Airport *Link*

Request for Project Change

MAY 2008

Queensland
Government

Figure 3-8A
North Western Connection **Changed** Project Surface Works and Elevated Structure

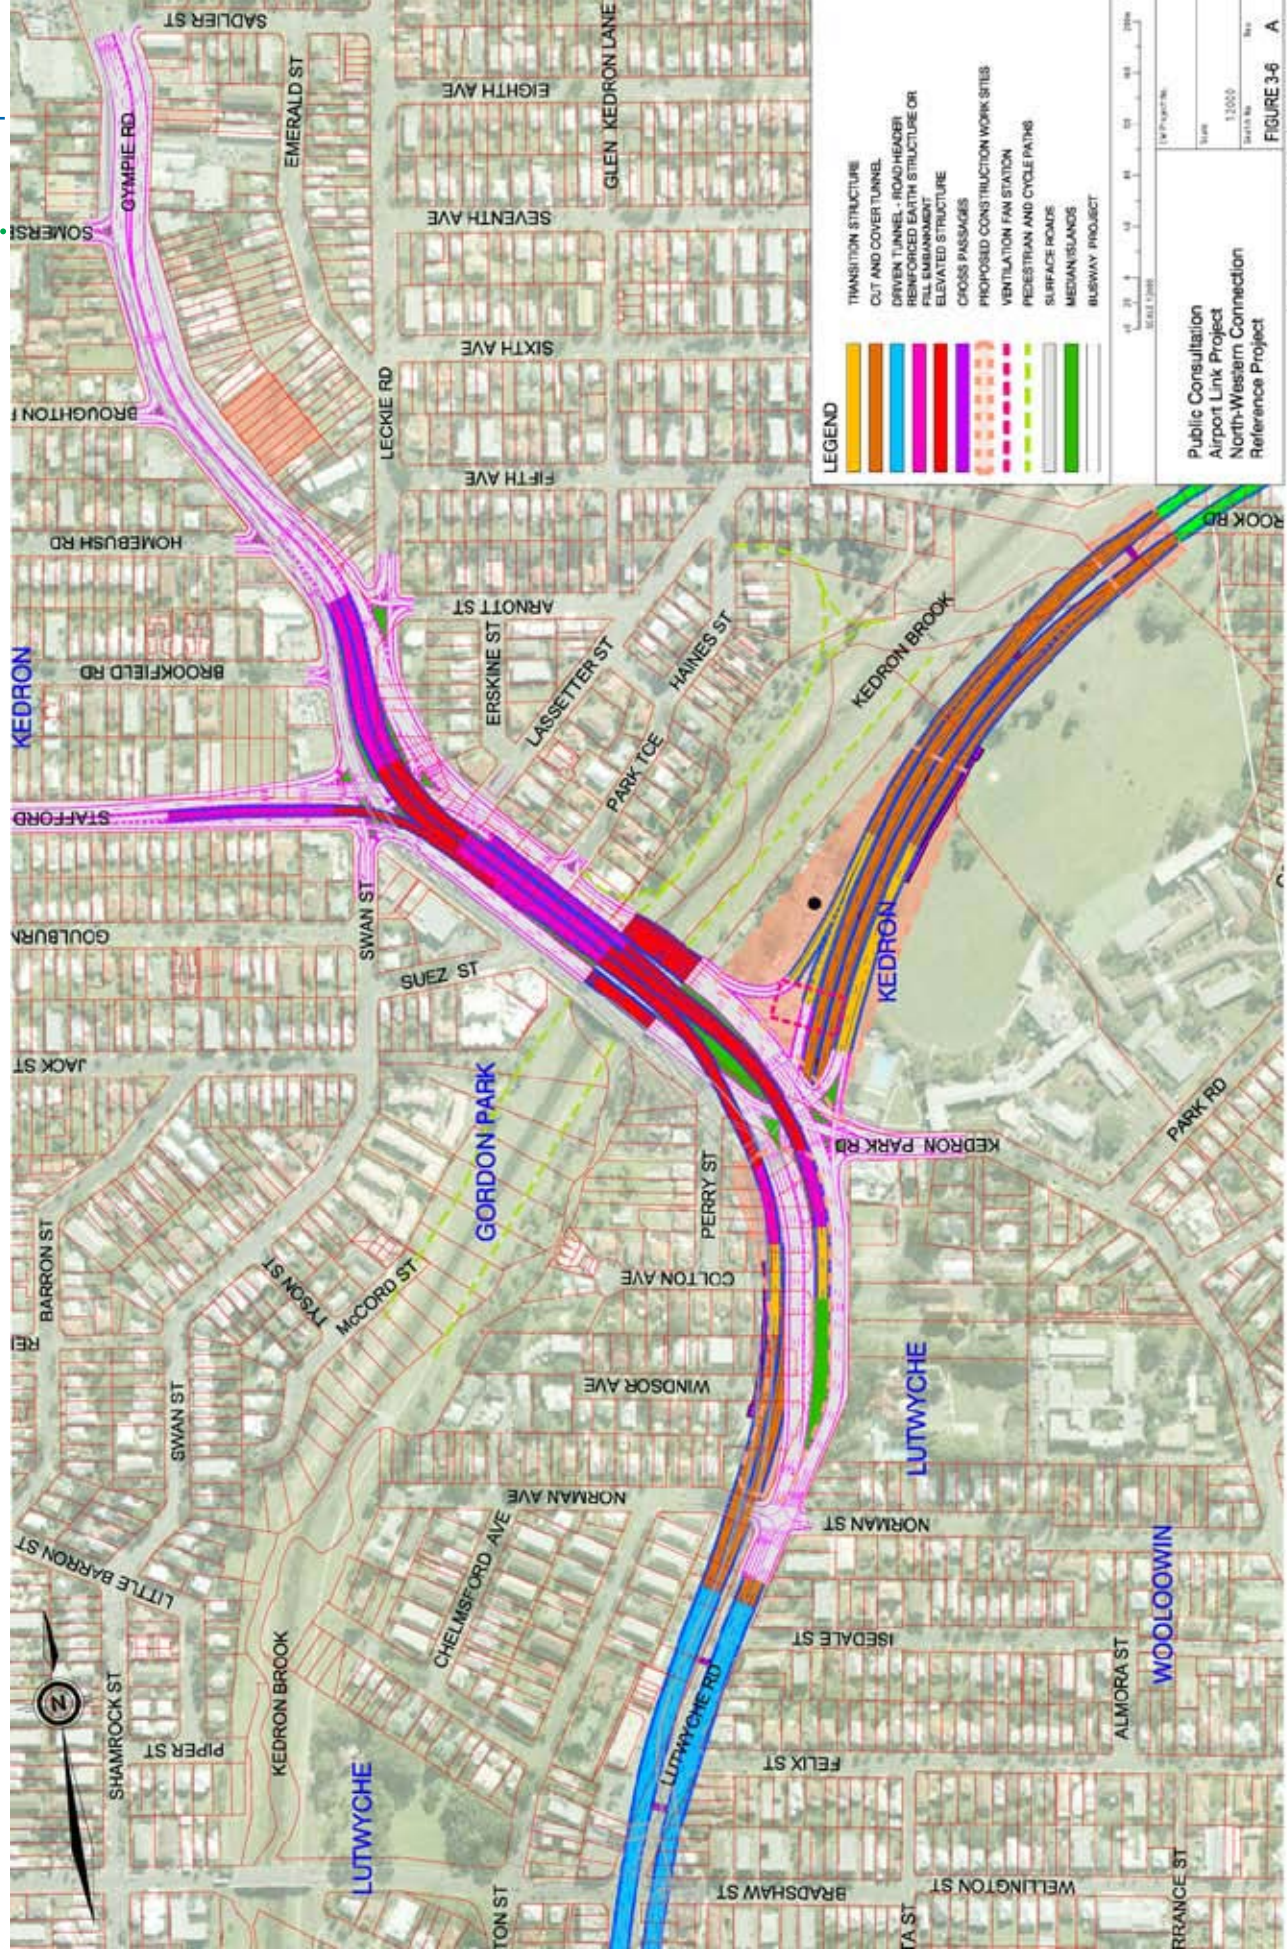
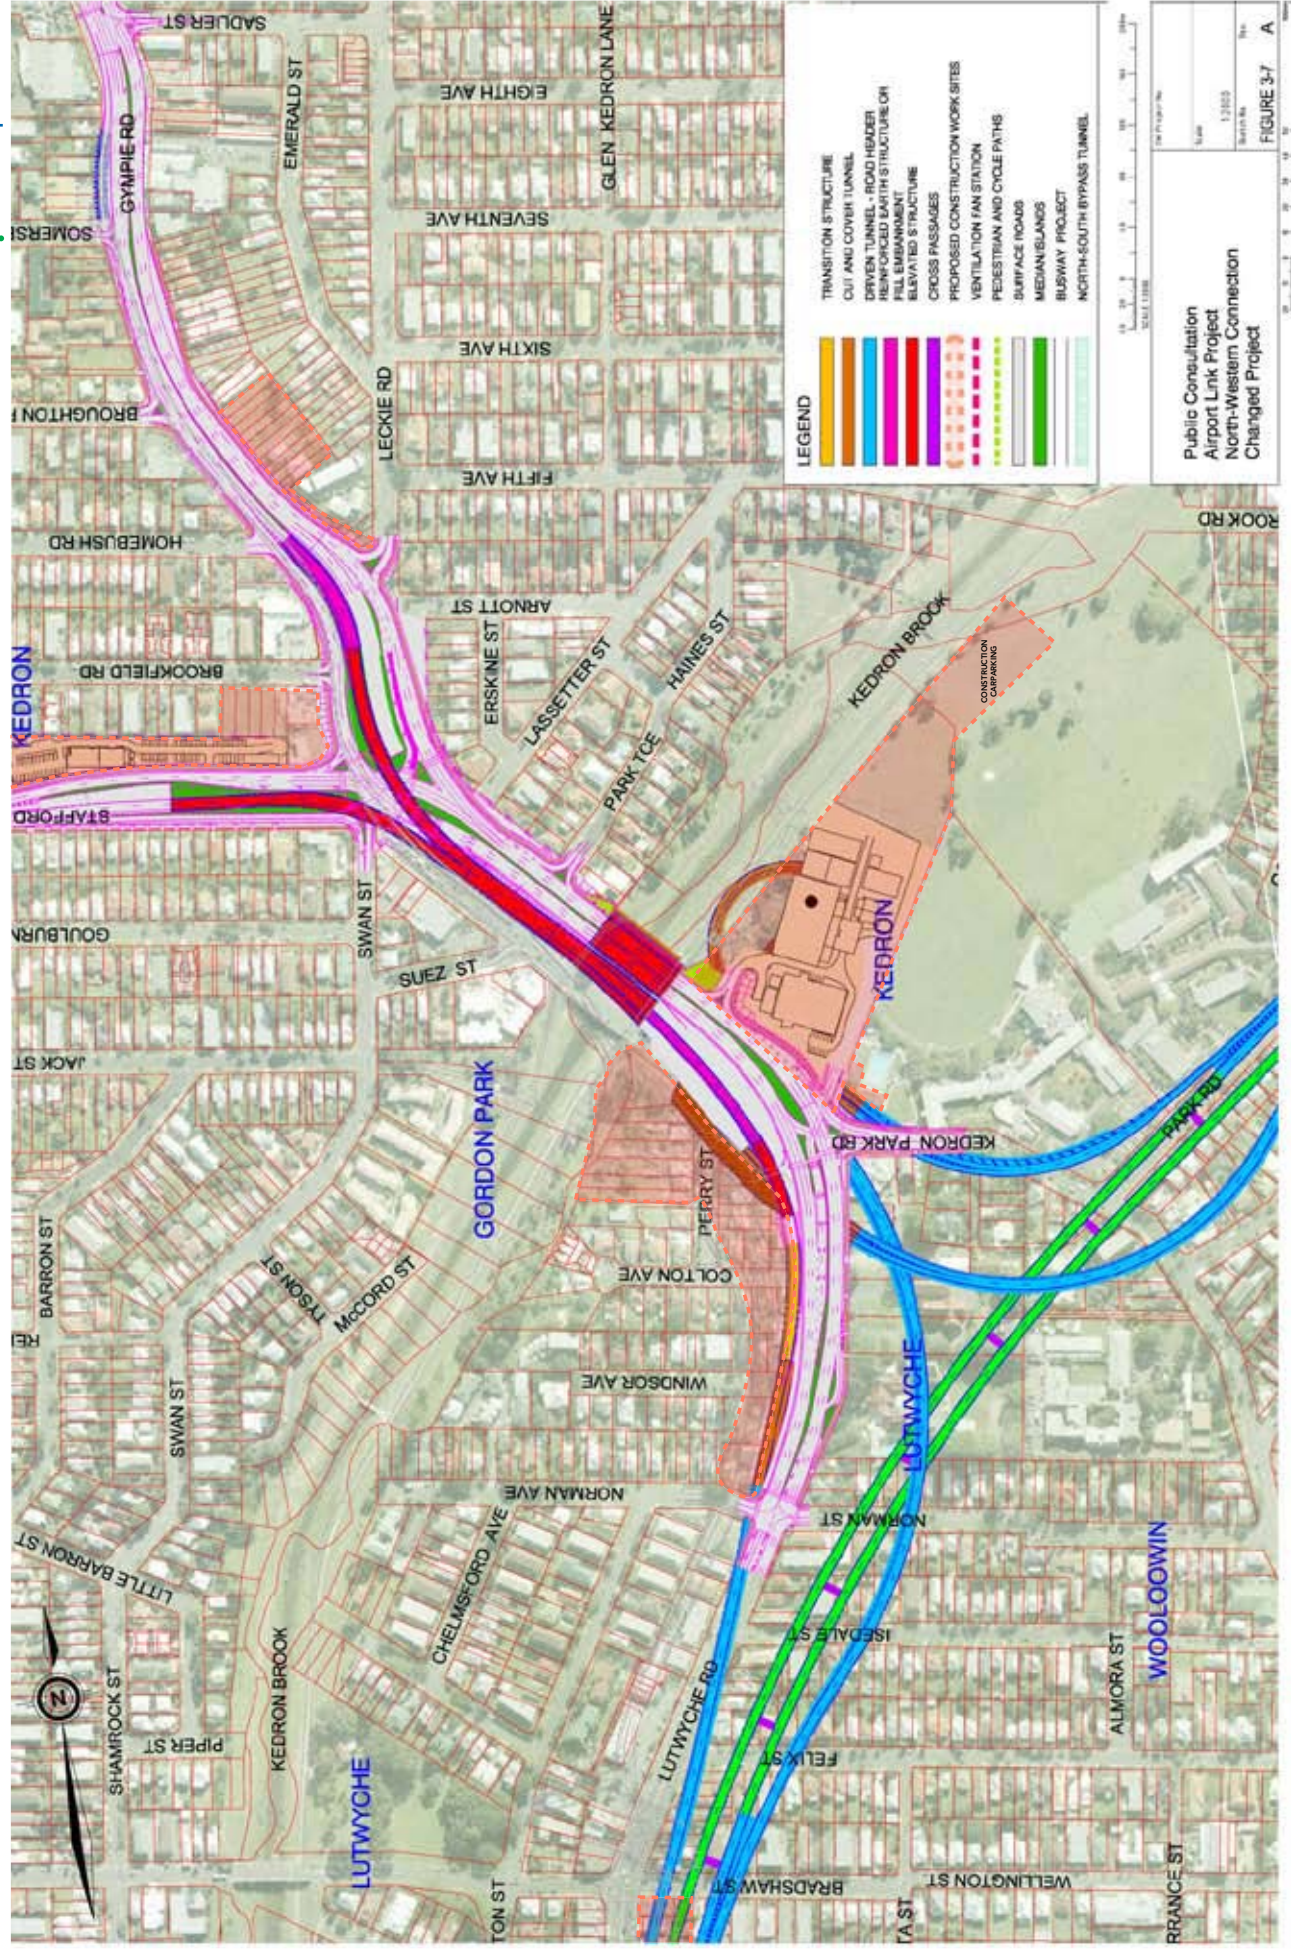
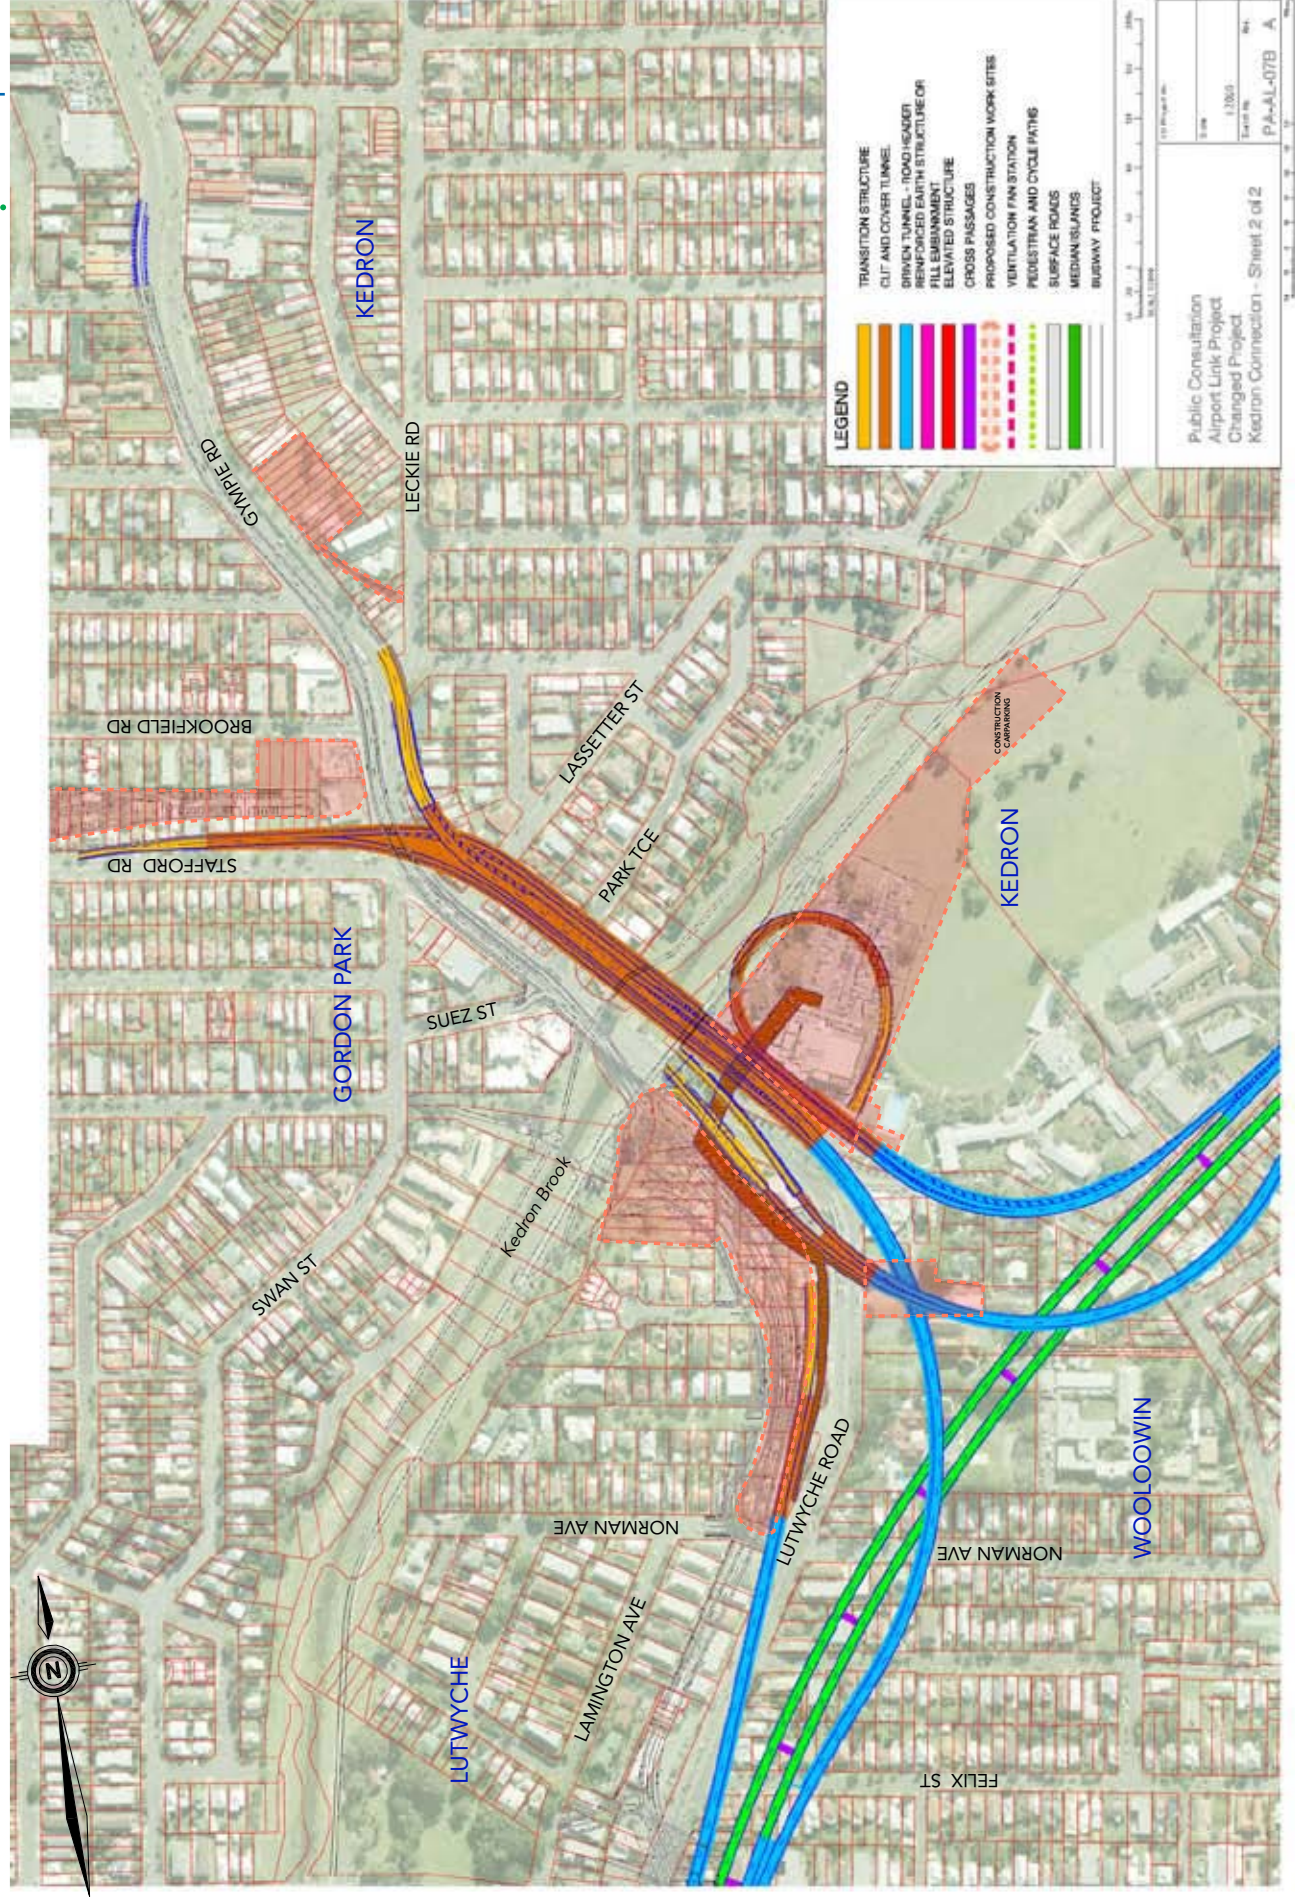
The design of the Kedron connection in the Changed Project also provides for the retention of the DES building south of Kedron Brook with access similar to the existing access from Lutwyche Road. This entry and exit would also provide access to the ventilation station.

A comparison of the Reference Project and Changed Project at Kedron is provided in **Figures 3-7, 3-8A, 3-8B, 3-8C, 3-8D** and **Figure 3-9**.
